REPORT OF THE PANEL
ON
EVALUATION OF GROUND-WATER FLOW IN FRACTURES
AT
THE PALO DURO BASIN

The stated charge addressed in this report is to assess the relative importance of, and availability of data to evaluate the fracture contribution to ground-water flow at the Palo Duro Basin sites in Texas. In arriving at our conclusions, the panel has reviewed pertinent publications, has been presented information from various participating contractors, and has had an opportunity to question these contractors. On the basis of these inquiries, we have developed our own conceptual model of ground-water flow along with the possible relevance of fractures within this conceptual framework.

FIGURE 1. Hypothetical schematic fracture styles considered by the panel for ground-water flow in the evaporite section of the Palo Duro Basin.

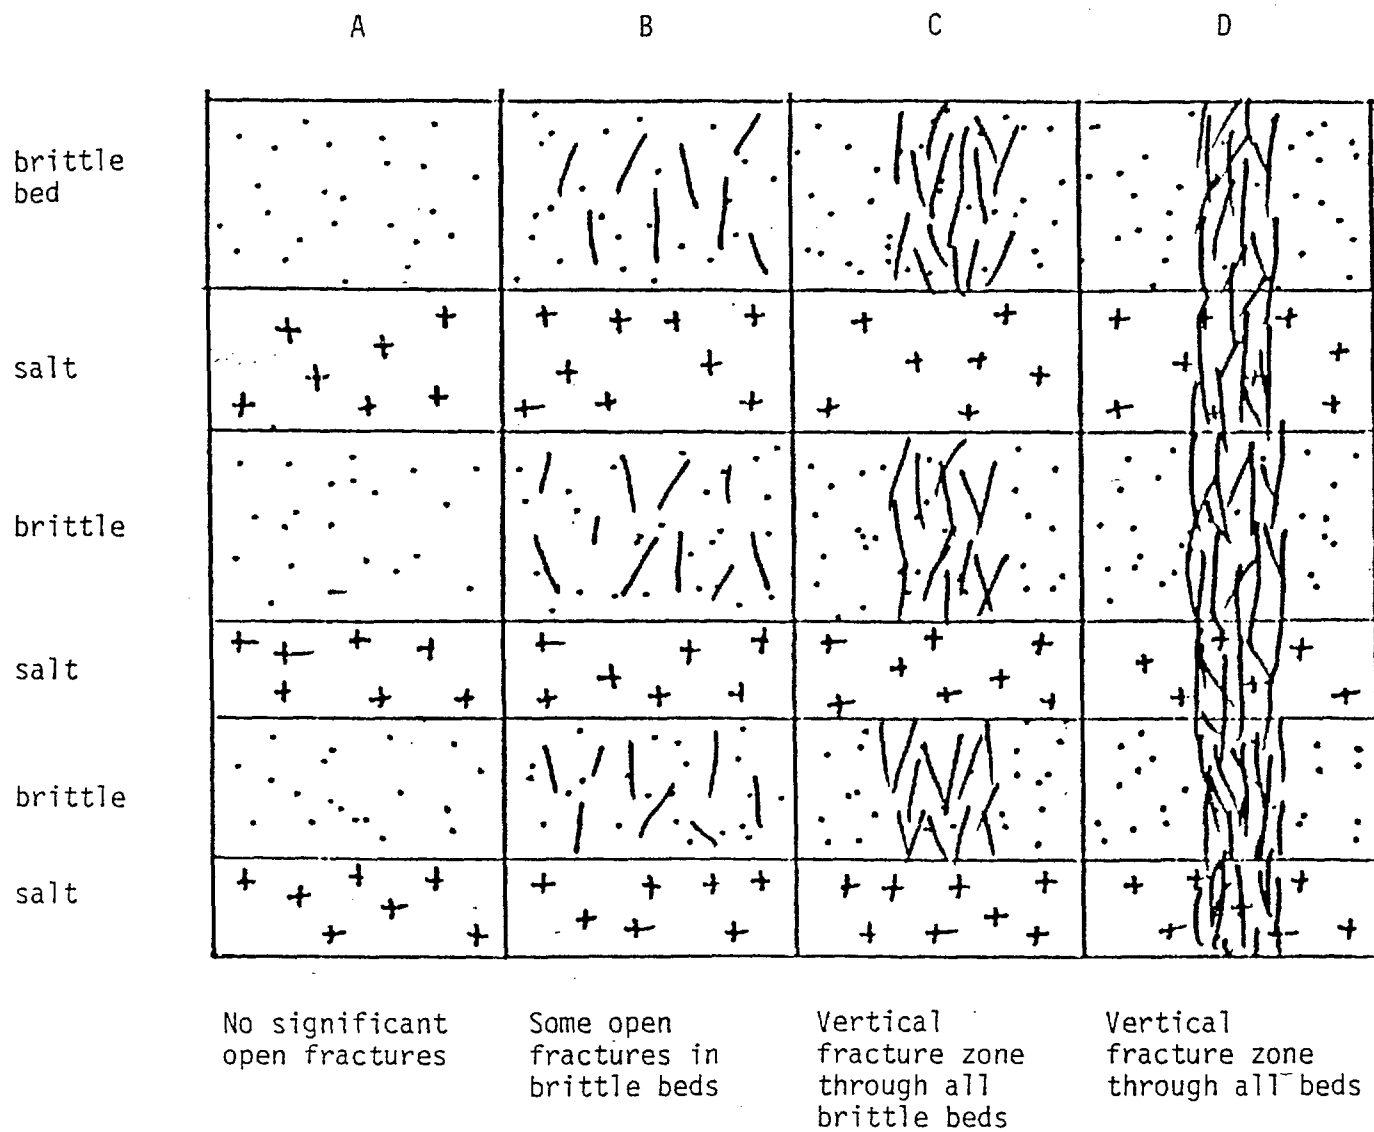
Depicted in Figure 1 are simplified examples of fractured and porous flow conditions that could be included in a Monte Carlo model. We consider Case A, a condition of non-fractured porous flow to be the expected or the most probable condition in the Palo Duro Basin. Probability distributions on the hydraulic parameters should be sufficiently general to account for some dispersed, low intensity fracturing in what we term the brittle or non-salt units. This type of fracturing (depicted in Case B, Figure 1) should not necessarily be correlated between geologic units. Case C represents fracturing associated with structural discontinuities that may be propagated, from the basement, upward to the ground surface. More specifically, this fracturing probably involves fracture flow through the non-salt units and porous flow through the salt units (Figure 1 and 2). Travel times calculated along this pathway, if possible, should include times for movement along mainly porous pathways (Cases A and B) to the vertical discontinuities. The actual position of this vertical zone should be treated as a random variable. Because this total travel path is thought to occur infrequently in the Palo Duro Basin, its contribution to the overall travel time distribution should reflect this low probability of occurrence.

Case D (Figure 1) is a situation where conditions of fracture flow are propagated along the entire length of a structural discontinuity. From our examination of the available data for the basin, we do not feel that

a case can be made at this time for the existence of this kind of pathway in the basin. Thus, we would recommend that Case D not be included in the Monte Carlo analysis.

FIGURE 2. Schematic representation of hypothetical fracture zone propagating vertically through brittle beds only of the evaporite section, as represented in Case C of Figure 1.

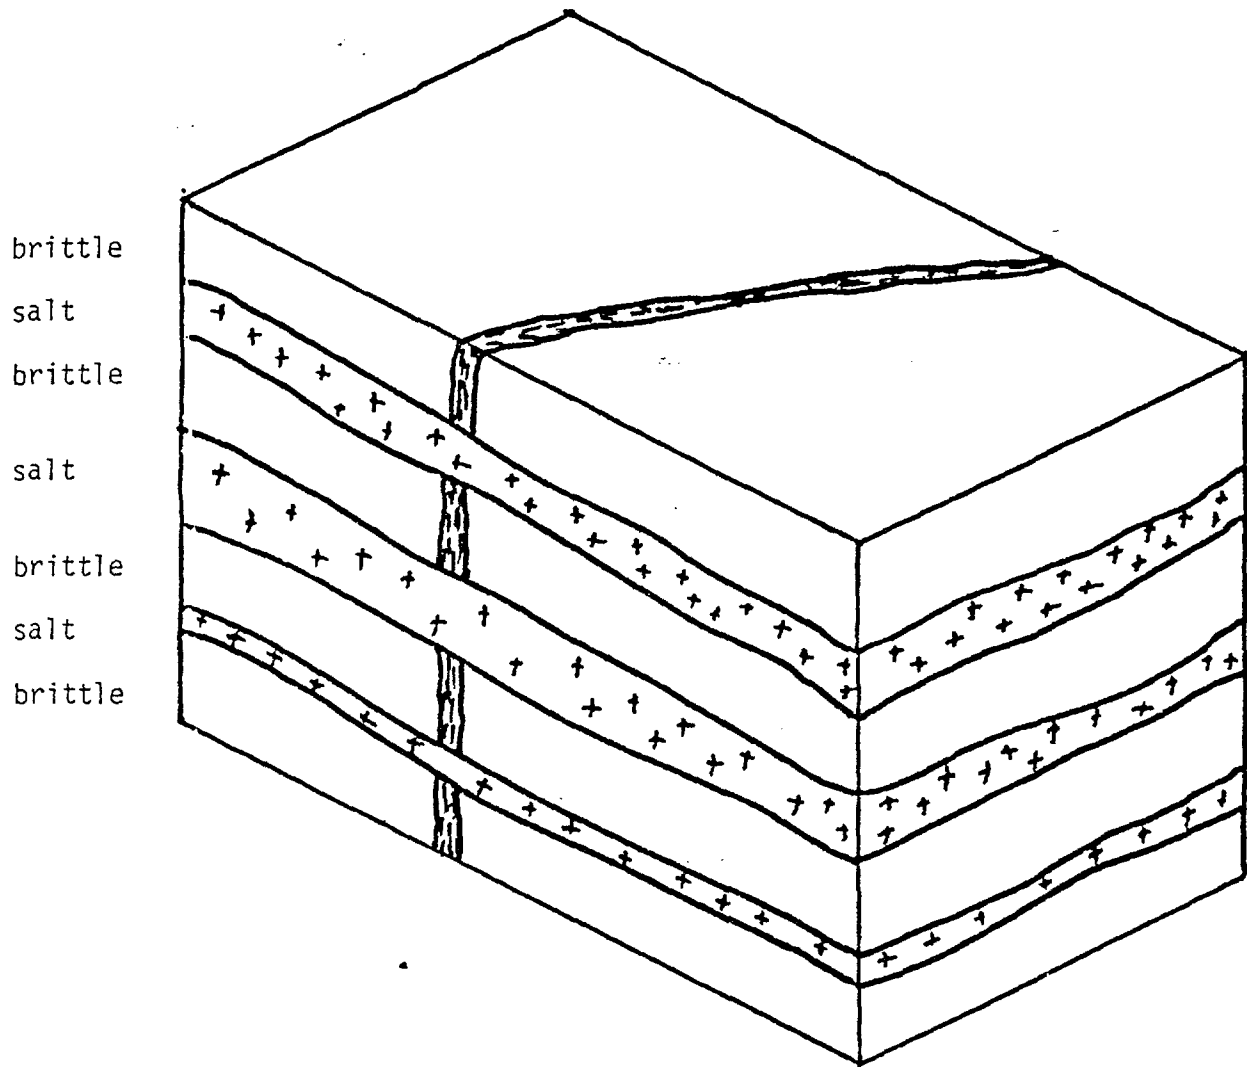
- o A low-probability fracture-controlled pathway should also be considered. Some analyses should be carried out assuming a vertical lineament feature penetrating the sedimentary stratigraphic sequence in the vicinity of the repository which provides higher permeability and lower effective porosity in the more brittle rock units only, and porous media flow through the salts.
